**Becklin & Whitney**  
*Consulting Engineers, Inc.*  
**139 1<sup>ST</sup> AVE. E, SUITE 100**  
**P. O. Box 471**  
**CAMBRIDGE, MN 55008**  
**PHONE (763) 689-5631 FAX (763) 552-5631**

RE: Review of Proposed Addition adjacent to  
Septic System Box Mound

The owner is planning to build onto the south side of the existing cabin. A Septic System Box Mound is also being installed on west side of property. The Septic Tank is existing. We were asked to comment about any effects on septic system that would be caused by cabin addition.

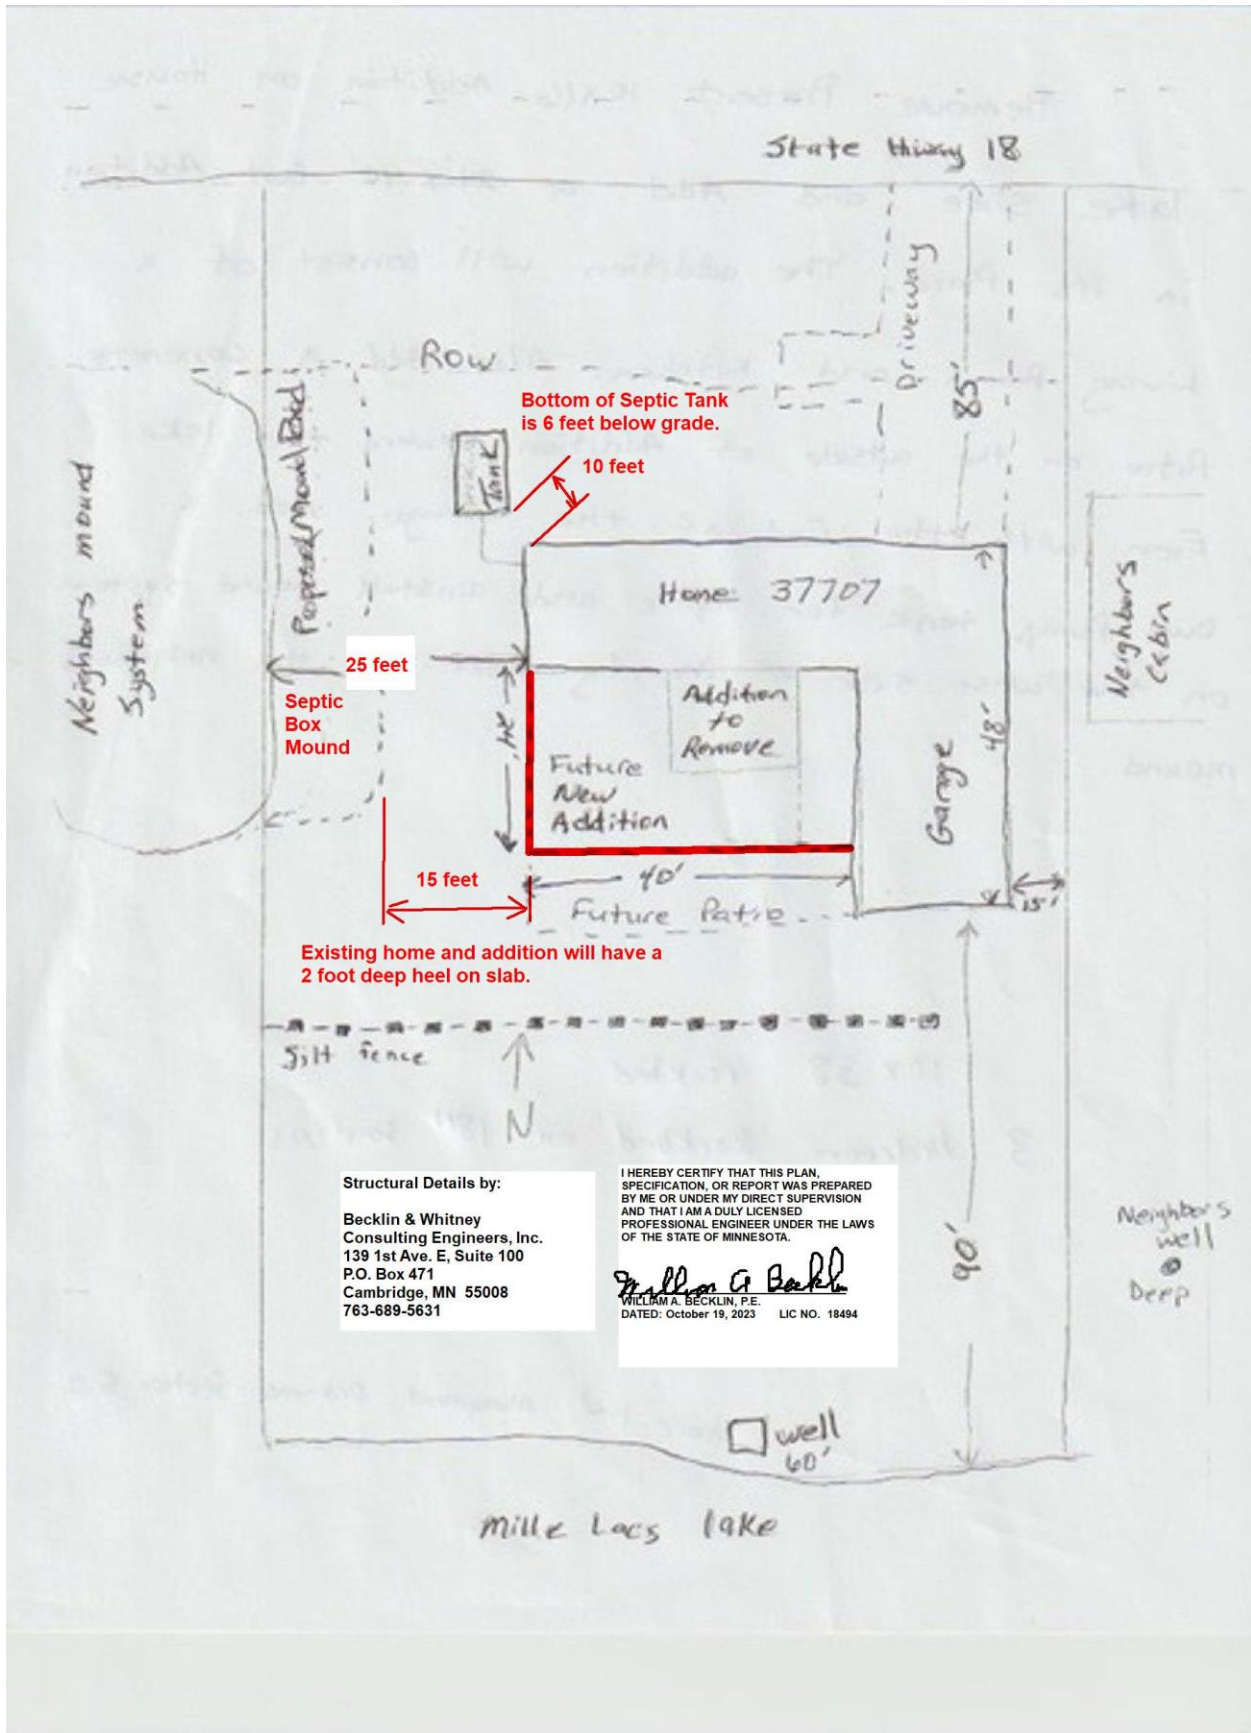
Bottom of Septic Tank is 6 feet below grade.

10 feet

25 feet

Septic Box Mound

15 feet

Existing home and addition will have a 2 foot deep heel on slab.
